Title: TY240-240320-BO 2.4" TFT LCD module on break out board With optional 32MB NAND Flash	
Revision : Rev 1B	Size : A4
Date: 26 Nov 2007	Drawn by : TechToys Company

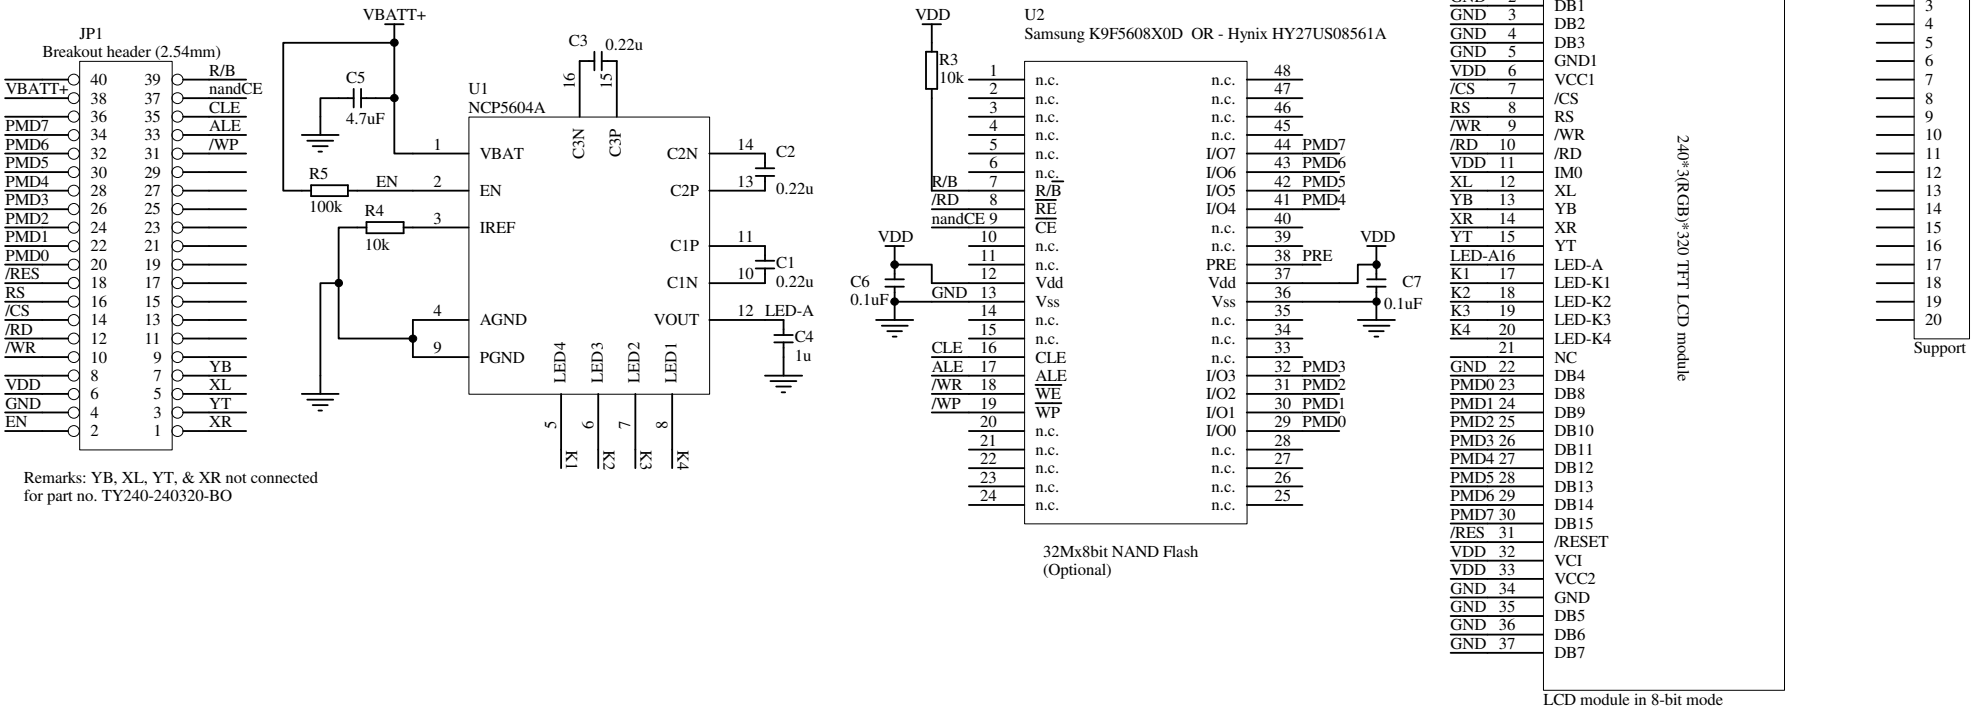
Rev 1B:
1. Change TI's TPS60230RGTT to Onsemi's NCP5604A
2. Use battery input for NCP5604A for development of hand-held devices
